36 Case Study: Seabrook Station Unit 1 ASR Problem	3
36.1 Reported Analyses/Investigation	5
36.1.1 Background	5
36.1.2 The Process	6
36.1.3 License Amendment Request	7

More specifically, we examine the response by a single nuclear reactor's private owner and the governmental regulator to aging and cracking issues due to ASR. The reactor, Seabrook Station Unit 1 in New Hampshire, owned and operated by NextEra Energy Seabrook LLC, is the first and only United States reactor where ASR has been discovered. ASR affects significant safety structures at Seabrook, including the containment enclosure building (CEB) which surrounds the reactor containment and protects against radiation releases from the reactor core. Because the adequacy of NextEra's program for detection and monitoring of ASR at Seabrook was subject to an investigation and licensing process by the regulator, the U.S. Nuclear Regulatory Commission (NRC), the response to ASR at Seabrook is relatively well-documented. As previously discussed, ASR is a highly complex problem that poses significant challenges in any attempt to assess it. In the case of a nuclear reactor, the stakes are particularly high, given the increase in s

Fig. 36.5: Splitting structural crack, from Wald, Martinez, and Bayrak [88]

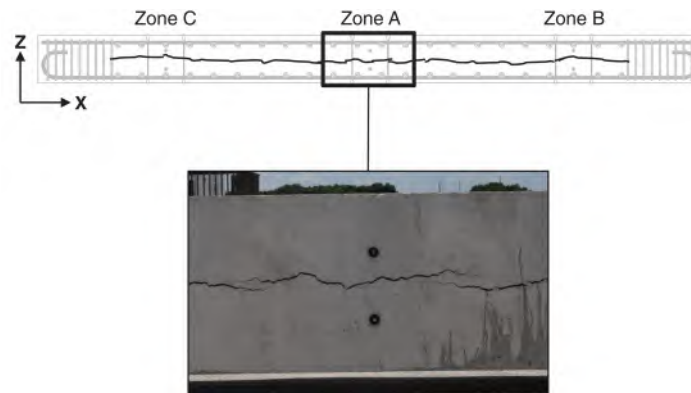
The relevance of such an (unanticipated) crack, one which inhibits tensile stress transfer, can not be discarded. They simply were not anticipated during planning purposes, caught NextEra by surprise (though any basic understanding of ASR expansion would have anticipated them) and should disqualify test results. An biological analogy would be if a Petri dish had been contaminated by an external agent, thus rendering results questionable. Similarly, a basic tenant of experimental mechanics is to avoid any secondary source of uncertainty. Indeed, one can not discard the likelihood that the presence of the splitting crack has not affected the trajectory of the shear-flexural crack in Figure 36.5.

Fig. 36.9: Reported calibration for Seabrook based on NRC safety evaluation [61]

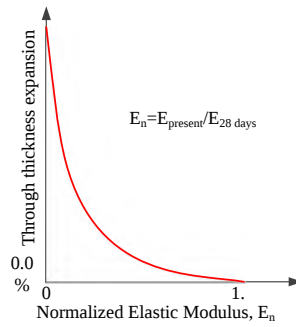
However, the problem is that the same laboratory mix design was used to establish the correlations for the CI and out-of-plane expansion, Figure 36.9. In this instance, having reactive concrete is not sufficient; there has to be a mineralogical similarity. Indeed:

**Fig. 36.11: Directional expansion measurements from Wald, Martinez, and Bayrak [88]**

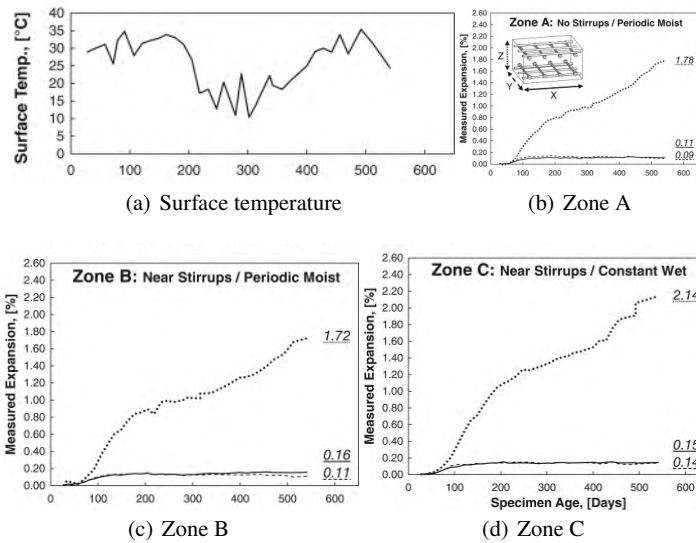
36.2.2.2.2 out-of-plane Expansion As shown in Figure 36.11 the bulk of the volumetric strain is along the unreinforced out-of-plane expansion. This value is to be measured when CI exceed certain threshold values (Table 36.2). The method has been calibrated with measurements from the FSEL (Figure 36.9). Yet this method is most unreliable for the following reasons:

Furthermore, as shown in Figure 36.11 the in-plane strain measurements, upon which the load factors are built, are negligibly small compared to the out-of-plane strain. Hence those amplifications factors can-not be representative.

Fig. 36.14: Possible explanation for splitting cracks based on Wald, Martinez, and Bayrak [88]

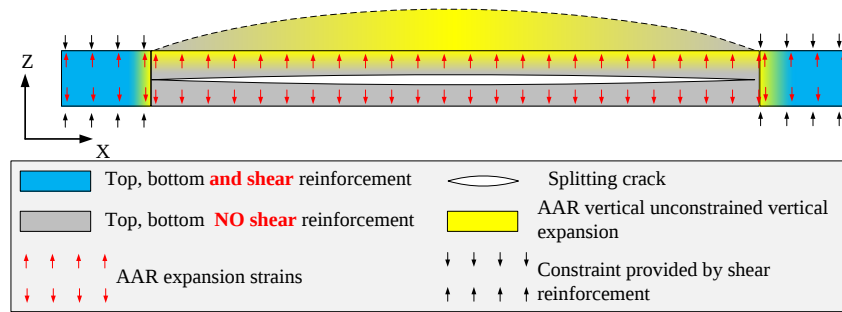
36.2.2.1.3.1 Splitting crack As noted above (§36.1.3.1.3.2), a splitting crack occurred in all specimens prior to testing. The cause of the crack is pretty straightforward. ASR being opportunistic will redirect the expansion along the two restrained directions to the one which is un-reinforced, Figure 36.14.

The explanation is quite elementary, Figure 36.14. AAR being “opportunistic” will expand in the unconstrained direction. Hence, since there was no shear reinforcement in the center, Figure 36.4(c), expansion took place in that zone. At some point, the AAR induced stress exceeded the tensile strength and a splitting crack snapped. Concrete being a brittle material, one would suspect that this was accompanied by a loud noise. Indeed it is a common practice to have acoustic emission sensors on the surface of specimens when internal cracking may occur, [83]).

Fig. 36.15: Finite element simulation of specimen splitting

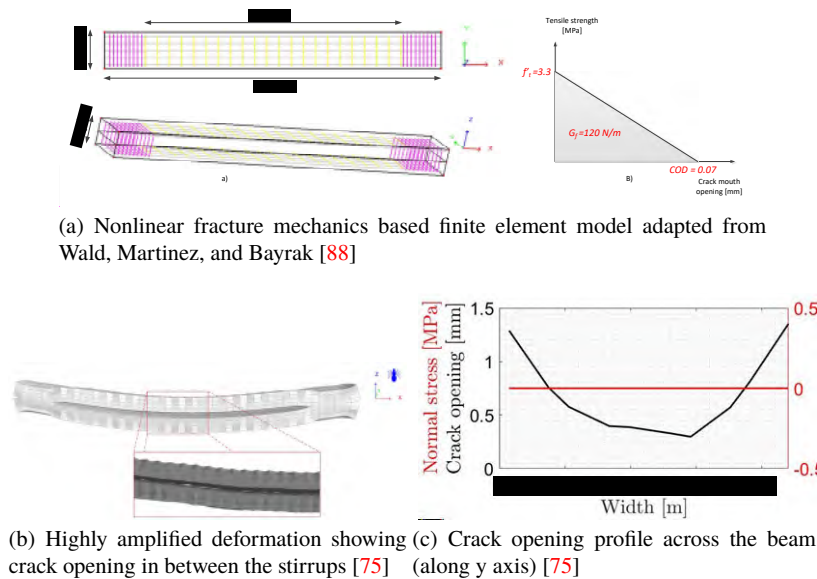
1. Because of unconstrained vertical expansion, indeed a crack formed in the portion of the beam that is not resisted by shear reinforcement (stirrups) as shown in Figure 36.15(b). The authors conclude that this crack is comparable to the crack observed in the LSTP, Figure 36.5.

2. At midspan, the computed crack profile is shown in Figure 36.15(c). It matches what has been reported by NextEra, that is the crack opening is largest on the edge. We estimated it to be 1.4 mm (this may be less than what was determined, but again in the absence of tests we had to estimate the fracture energy G_F).

Again, it should be emphasized that this analysis does not pretend to be quantitatively exact; however, it is most certainly qualitatively correct and based on sound, established, fracture mechanics models. Hence, we can safely assert that the observed splitting crack is far more serious than asserted by NextEra.

Fig. 36.16: Issues about shear tests

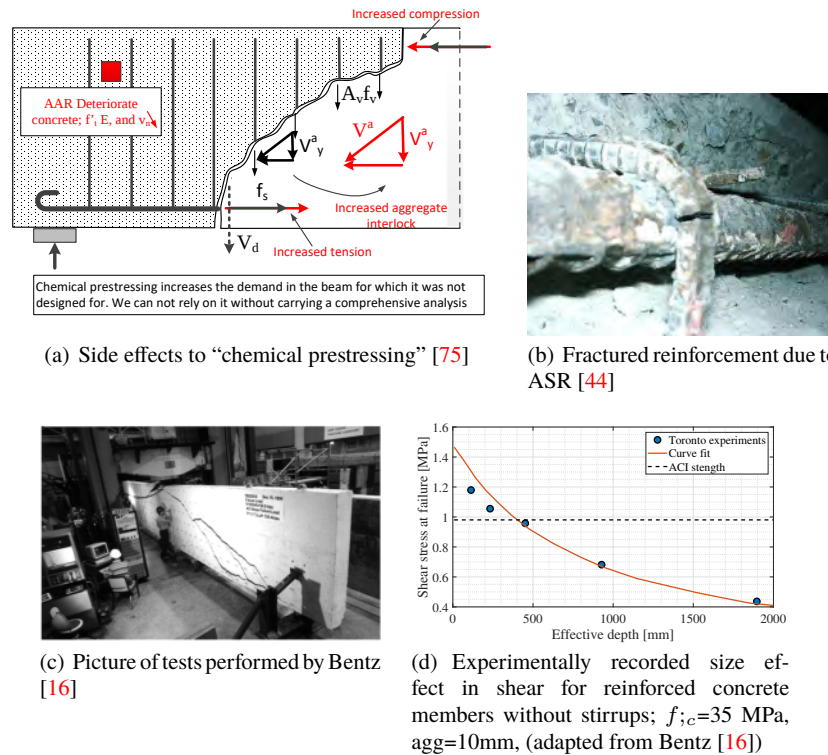
The phenomenon is simply illustrated in Figure 36.16(a) based on the classical free body diagram of flexurally-cracked reinforced concrete beams [22].

36.2.2.1.3.3 Fracturing of stirrups Another possible “side effect” of restrained expansion is that it may either yield or fracture the stirrups that provide both shear reinforcement as well as confinement for the concrete (thus increasing its strength) [40]. Such a failure did occur [44], Figure 36.16(b).

The phenomenon of creep or relaxation was completely ignored by NextEra. As a result, the LAR fails to account for the fact that the full beneficial effect of chemical prestressing is only temporary, and will be reduced with time.

(a) Temperature and relative humidity distributions across the wall

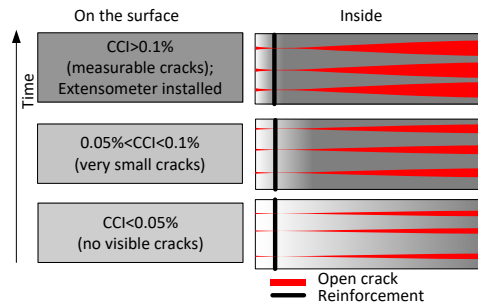
However, it is important to observe that, unlike the consistent temperature and humidity conditions created for the beams in the LSTP, neither the relative humidity nor the temperature is constant across the 30-48" containment structure walls. This is schematically illustrated by Figure 36.17(a).

NextEra has attempted to avoid sharp gradients in the ASR expansion by “smoothing” its distribution across zones of different measured expansion. But that is not a realistic or conservative approach. In reality, there is potentially a significant gradient of expansion across the thickness that should be modeled (Figure 36.17(a)).

Fig. 36.18: Concerns about out-of-plane expansion measurements

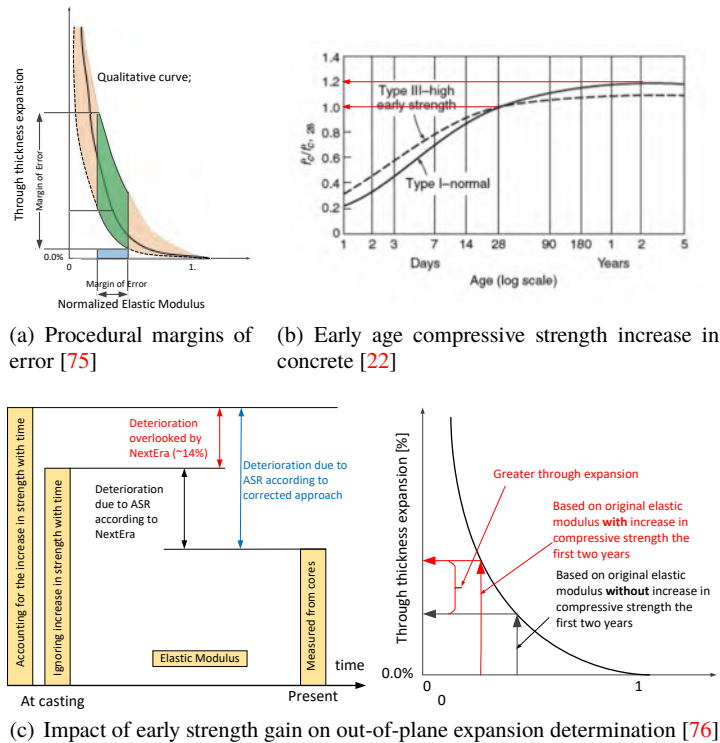
- As described above, the difference in mineralogy will result in different expansion characteristics (due to the microcracking).
- Values of the compressive strength measured in mid 1970's are likely to be: relatively few, not accurate enough to be applied with Equation 36.2, Figure 36.18(c) (20% strength increase will result in $\sim 14\%$ increase in E).
- A most critical component of the process is the determination of the ASR induced deterioration. This hinges first on Equation 36.2, but also on data collected at the FSEL, resulting in a highly approximate phenomenological model⁸ that estimates expansion in terms of normalized elastic modulus, Figure 36.9. As shown in Figure 36.18(a) two experimental errors are compounded:

- Vertical axis: expansion is determined in the laboratory under ideal conditions, with concrete whose representativeness *vis à a vis* of the one at Seabrook given that “mineralogically” speaking they are different (§36.2.2.1.2). Even if the mineralogy was indeed correct, any time precise and critical measurements are to be taken, margin of errors must be reported.

- Concrete gains in strength the first two years (about 20%) [22], Figure 36.18(b). Ignoring this will result in an underestimate of the ASR.

Fig. 36.19: Crack patterns caused by reactive sand and aggregates

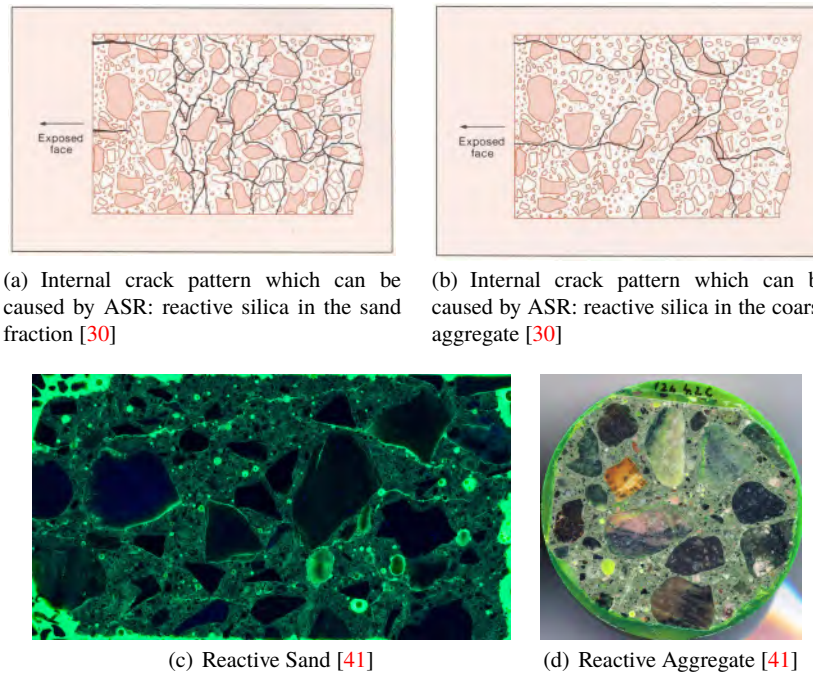
36.2.2.2.3.1 Internal Cracks There is ample evidence that ASR will cause internal micro-cracking (Figure ??) [38]. Furthermore, sand and gravel will cause drastically different internal crack patterns, Figures 36.19(a) and 36.19(b) [30]. This is further evidenced by Figures 36.19(c) and 36.19(d) which show images of concrete with reactive sand (cracks run thorough the paste, impregnated and polished sample in UV light) and an image of reactive gravel (diameter 5 cm, impregnated and polished sample for SEM) courtesy of Leemann [41].

The key takeaway is that NextEra has conducted *visual examination* to detect cracking, with the expectation that cracking may mean crumbling. This will be a false-negative reading of the situation because NextEra is looking for macro-cracks (visible with the naked eye), when it should be scrutinizing all the cores through petrographic analysis for unusual micro-cracking, and understanding that those micro-cracks are ominous and are likely to grow, coalesce and ultimately delaminate the CEB.

Fig. 36.20: Causes and examples of delamination in walls without out-of-plane reinforcement

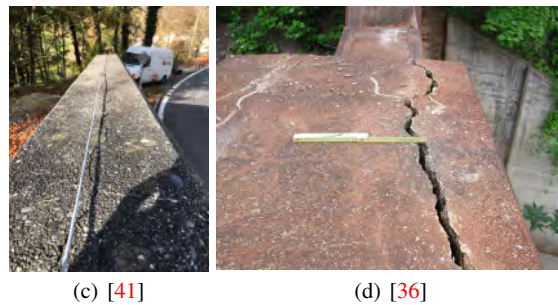
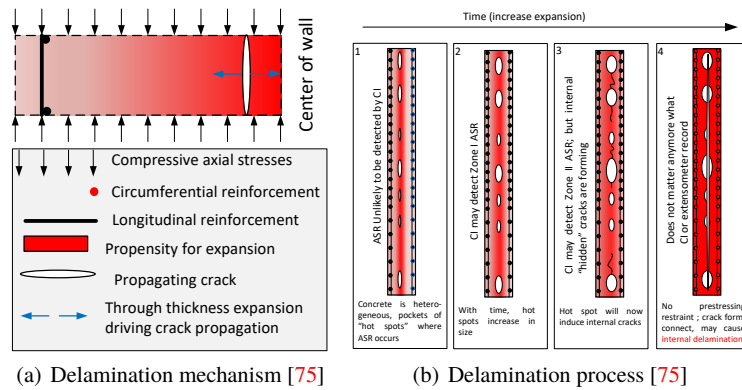
Again, ASR induced delamination will occur when swelling is constrained in two directions (in-plane) and unconstrained in the third (out-of-plane). Indeed, given all the swelling potential being now channeled along the weak direction, this could be problematic.

With reference to Figure 36.20(a) a segment of the wall is subjected to compressive stresses, and is reinforced only in the periphery vertically and radially. Micro-cracks are likely to coalesce in the center where the temperature and the relative humidity are highest, and this would be an in-plane crack. Due to ASR, expansion will be as indicated.

When the whole wall is considered, Figure 36.20(b), we consider four stages corresponding to different times. At first, expansion affects the center zone, and ASR would be localized in the middle where temperature and relative humidity are high. With time, the zone affected by ASR will expand but cracks are unlikely to “daylight” in significant way as a) the surface is likely to have dried over time; and b) the reinforcement will pinch the crack. As such, the cracks will remain confined to the center, and will eventually fully coalesce into a major internal in-plane crack.

Such a delamination did occur in the FSEL, Figure 36.5 (§36.2.2.1.3.1), and at Seabrook, there is a very strong likelihood that micro-cracks already exist.

Fig. 36.22: Stress induced anisotropy during volumetric ASR expansion [74]

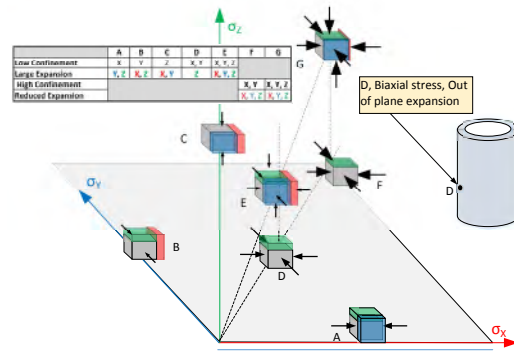
Most glaring, is the modeling of ASR as an isotropic thermal load. Indeed, a compressive stress greater than about 8 MPa will either limit or entirely prevent expansion in the corresponding direction [33]. Thus, under complex triaxial state of stress, expansion will redirect in the other directions (thus inducing an anisotropic expansion) [47] [42], Figure 36.22. NextEra's isotropic model of ASR at Seabrook would assign only one-third of that expansion to the out-of-plane direction [77]. This is clearly

unconservative, because it is anticipated (lack of radial confinement) and verified (Figure 36.11) that by far, most of the expansion occurs radially, i.e. out-of-plane.

Fig. 36.23: Problems arising from fitting $y = f(x)$ through interpolation [75]

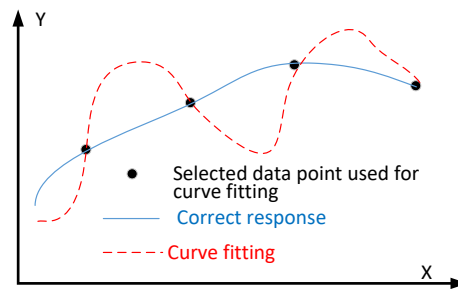
Furthermore, this procedure is akin to a glorified “curve fitting”. And these field measurement are not necessary, given that it is indeed expected that the finite element analysis would be able to capture the *essential* boundary conditions (§??), otherwise a wrong FEA program is used. What is lost on NextEra, is that “capturing” the response of few selected points (where the ASR expansion is imposed) does not make the analysis correct. This is illustrated by Figure 36.23 where one is able to fit a curve through a few data points. While this is an easy task, there is a near certainty that the model (curve in this case) will give erroneous values for the intermediary points.
